**VE (DI) FUEL-
INJECTION PUMPS**

**Workshop: EP
06.1994
0393 En**

Shutoff problems

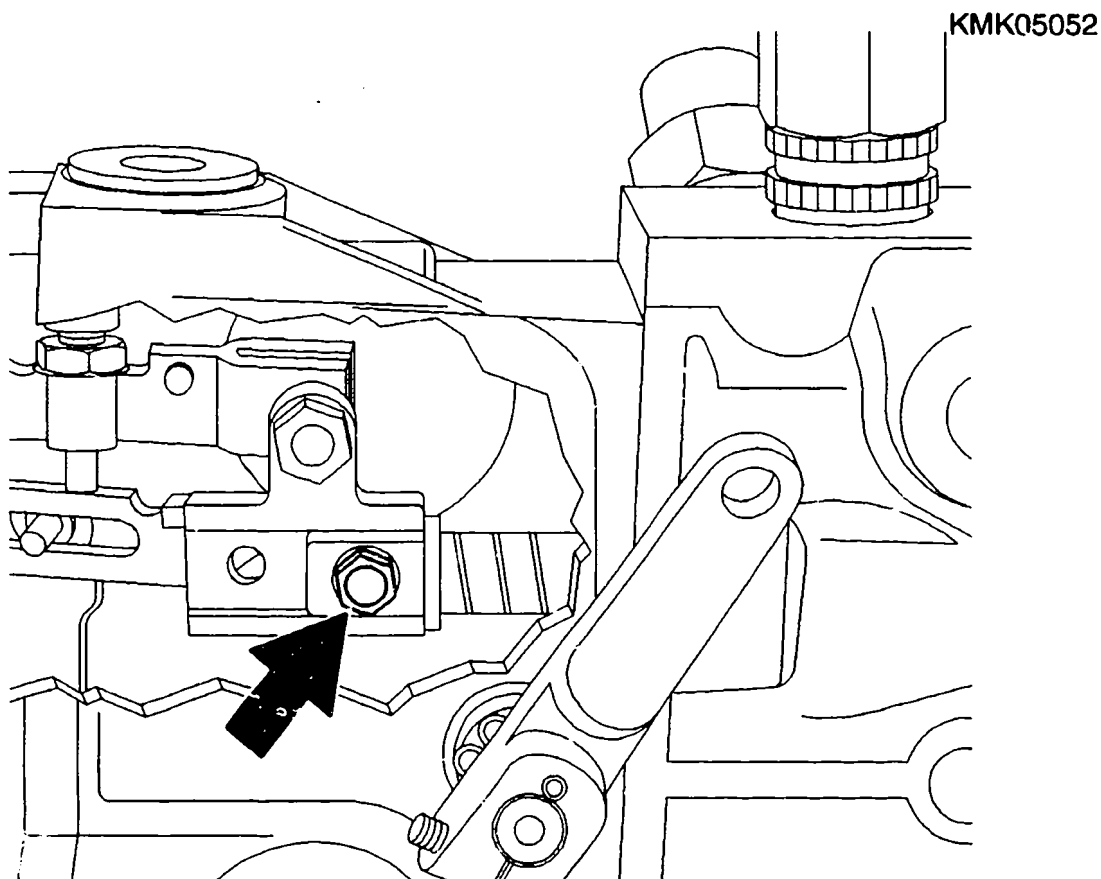
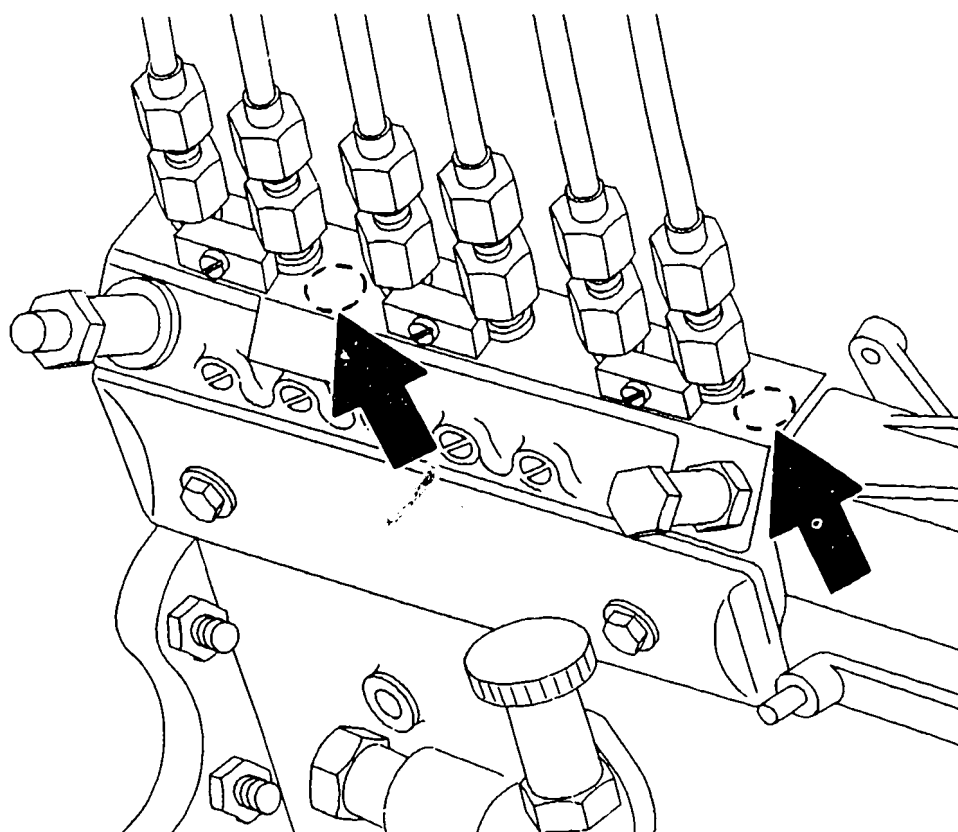
or the number "8" between cyl. #4 and #5

have been previously checked/corrected (see Ill. 3 and 4) and require no further action.

When you have completed the torque check or retorquing of the connecting bolt and nut, stamp the Number 8 between Cylinder Nos. 4 and 5 as shown in Illustration 4.

ARD ASSEMBLY

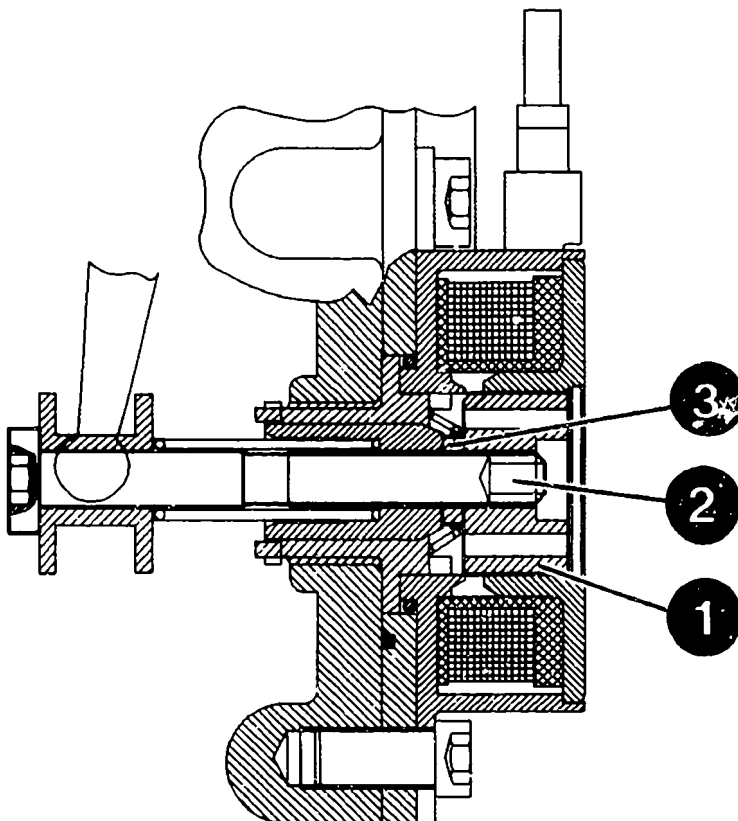
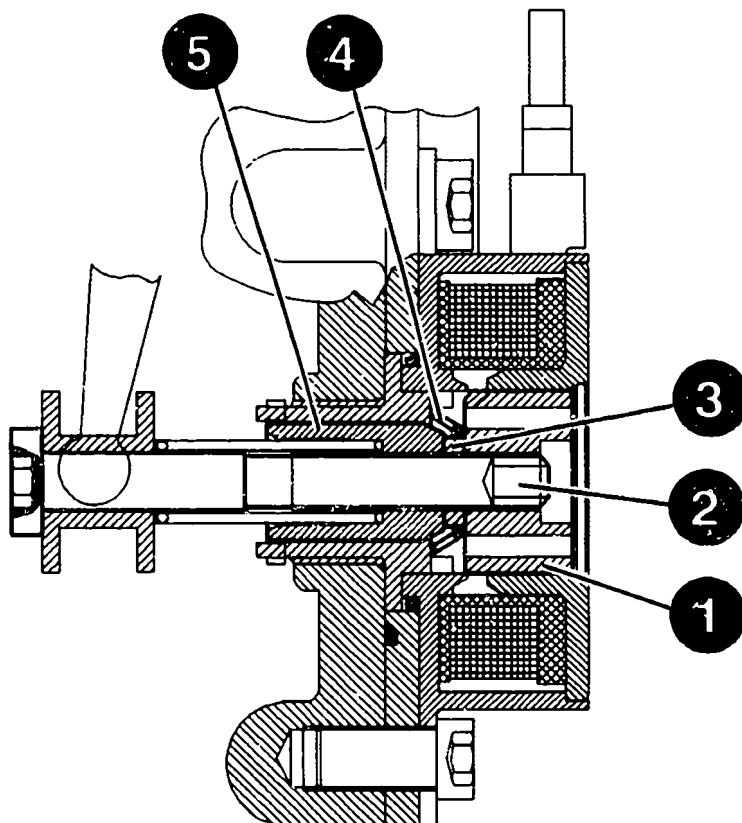
In the event of complaint "BUCKING
WHILST DRIVING" with the above IP
assemblies, replace shim, ARD stroke
at ARD solenoid in line with service
parts list.

Remove ARD fastening screws.
Loosen armature with socket wrench
KDEP 1911 - 0 986 612 599.
Whilst doing so, conterhold full-load
screw with 3 mm Allen wrench.
Remove return spring.
Remove shim, ARD stroke.
Replace shim removed (thickness of
shim 2.55 mm instead of 3.15 mm).

Insert return spring in correct position. Screw armature by hand on to full-load screw.

Insert socket wrench 0 986 612 599 in holes in armature and tighten to 5...7 Nm.

KMK04725

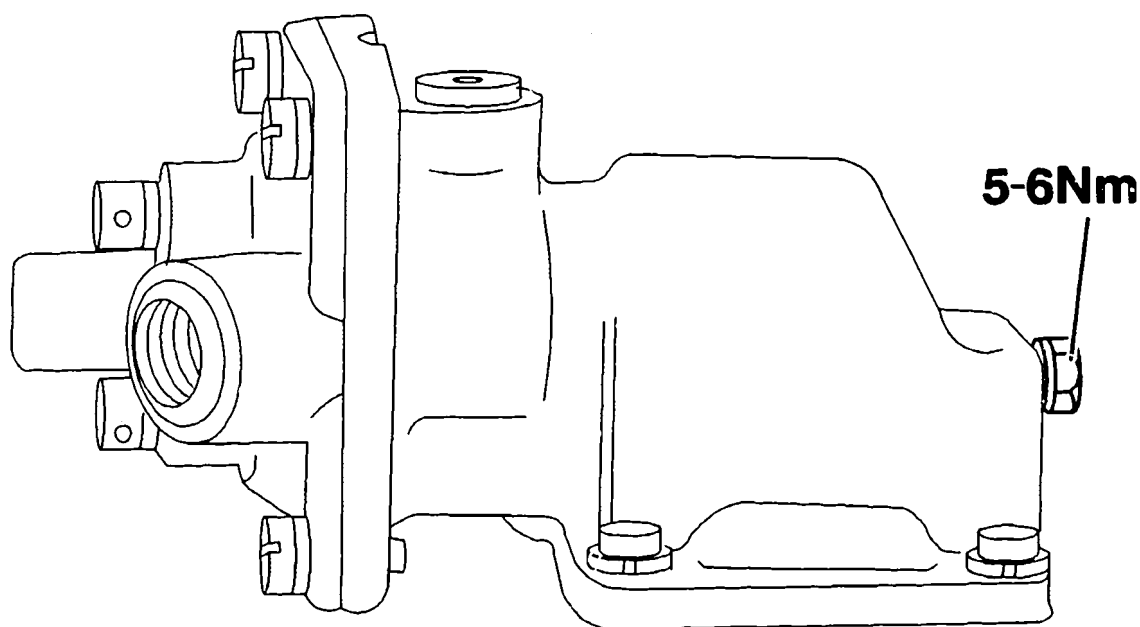
When performing starting fuel quantity adjustments on P-7100 injection pump combinations using top-mounted LDA assemblies, be certain to apply the correct torque to the locking screw and ensure that there is full movement capacity of the stop part after doing so. The specified torque of the locking screw is 5...6 Nm (see illustration).

KMK04726

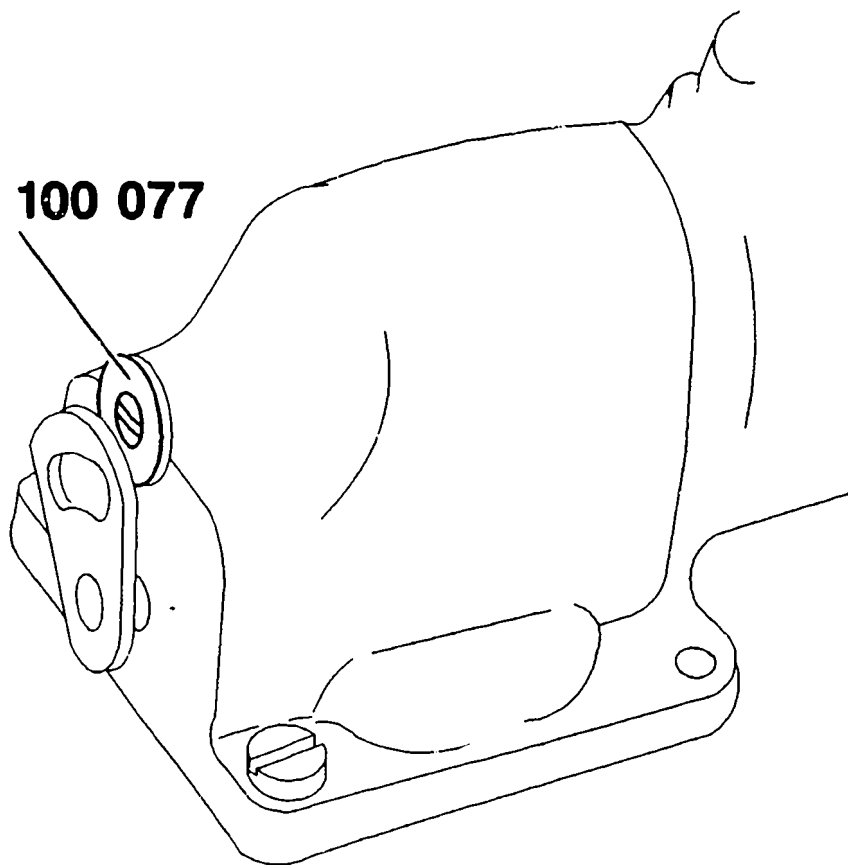
In the event that the stop part does not slide on the eccentric shaft when the setting screw is tightened, install a 0.5mm shim part number 2 420 100 077 between the adjusting quadrant of the shaft and the housing. Pass the screw threads through the center hole in the shim (see illustration).

KMK05223

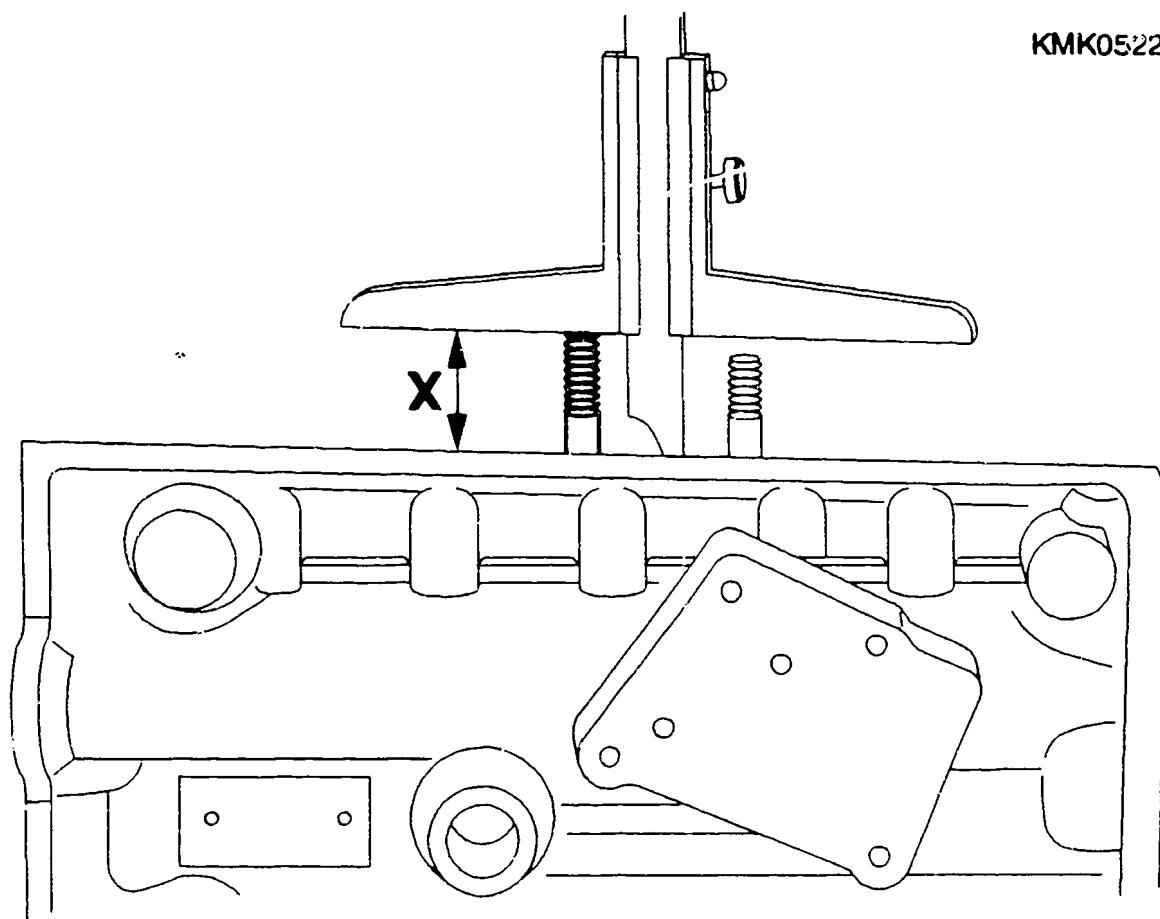
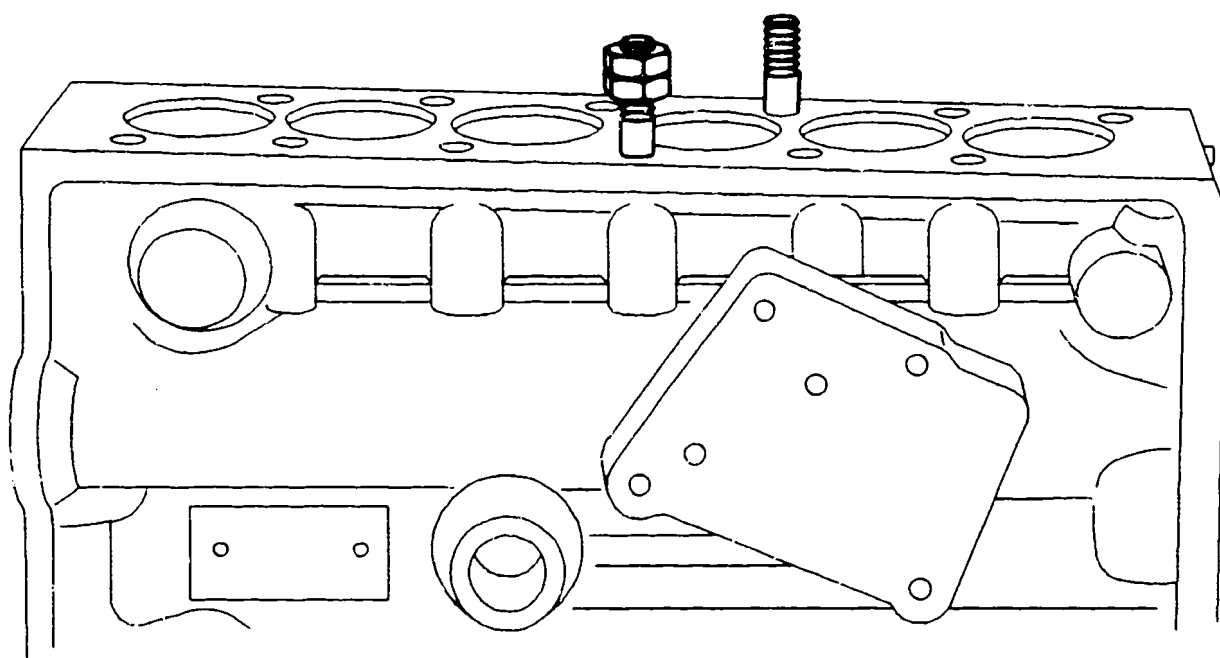
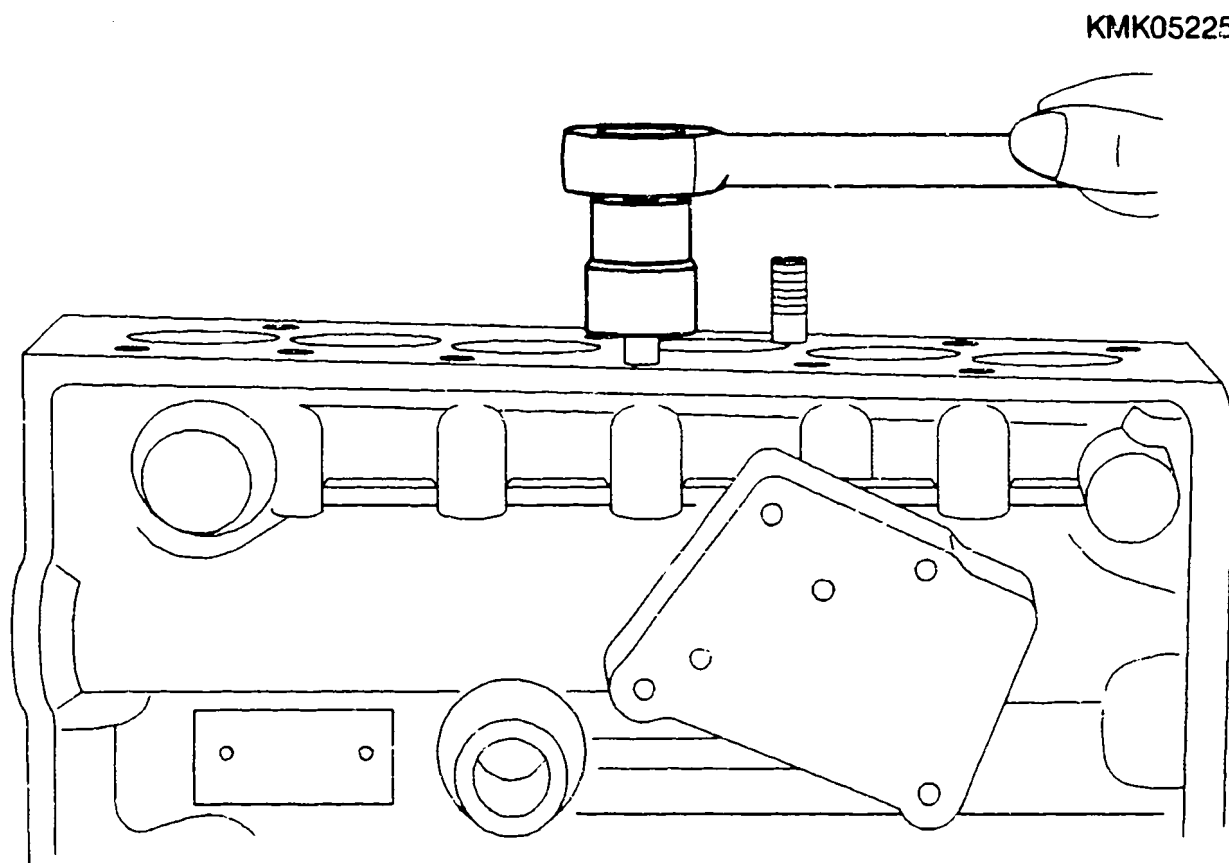
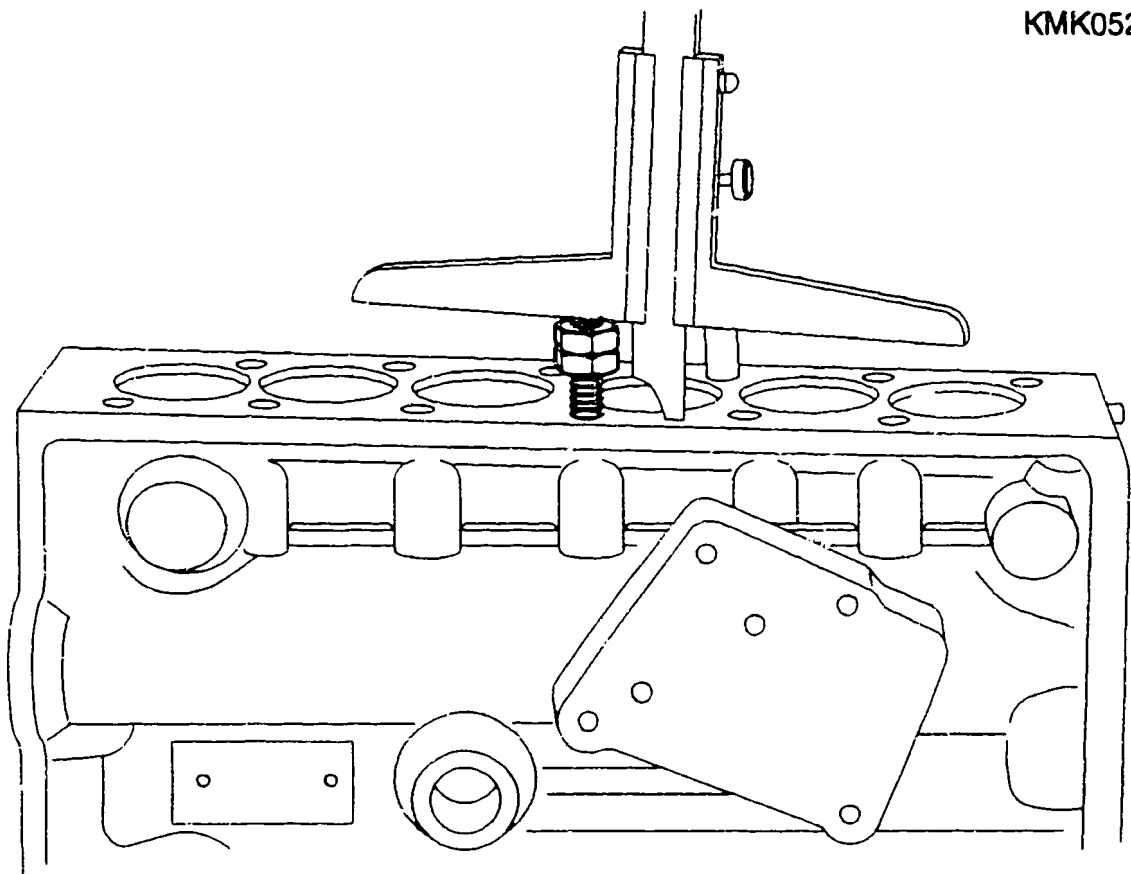
A stay bolt which has not been fully screwed into the pump housing can jeopardize correct functioning of the assembly union and, in extreme cases, result in fracture of the stay bolt.

- Short stay bolts: max. 26.80 mm
- Long stay bolts: max. 40.30 mm

If the dimension determined does not tally with the set value, screw two hexagon nuts onto the stay bolt and mutually lock. Position nuts such that one turn of stay bolt thread is still visible.

Screw in/screw out stay bolt, depending on dimension determined.

When screwing in, take care NOT to exceed prescribed tightening torque of 25...30 Nm.

- Short stay bolts: max. 26.80 mm
- Long stay bolts: max. 40.30 mm

KMK05673

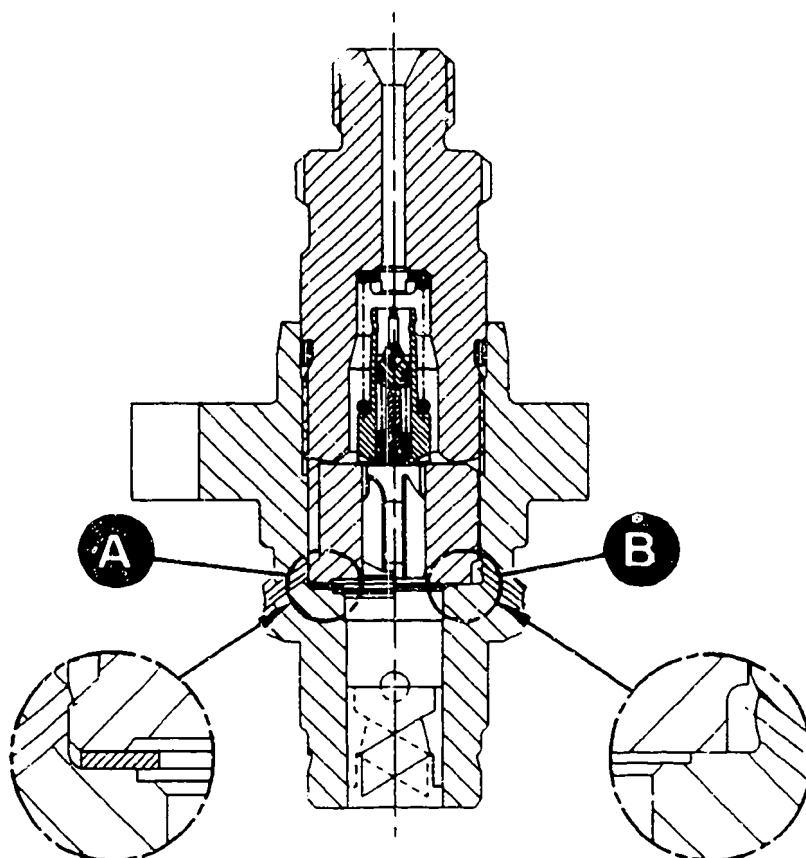
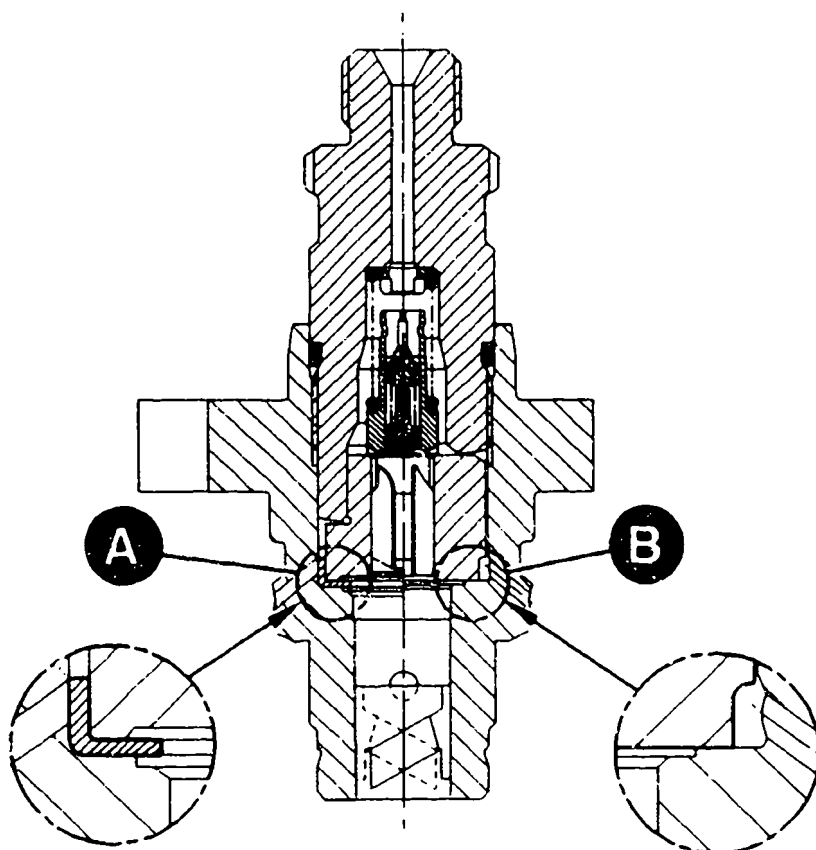
The two delivery-valve soft seals indicated below are currently standard:

Arrow A - DV seal with sealing cap

Arrow B - "hard seal"
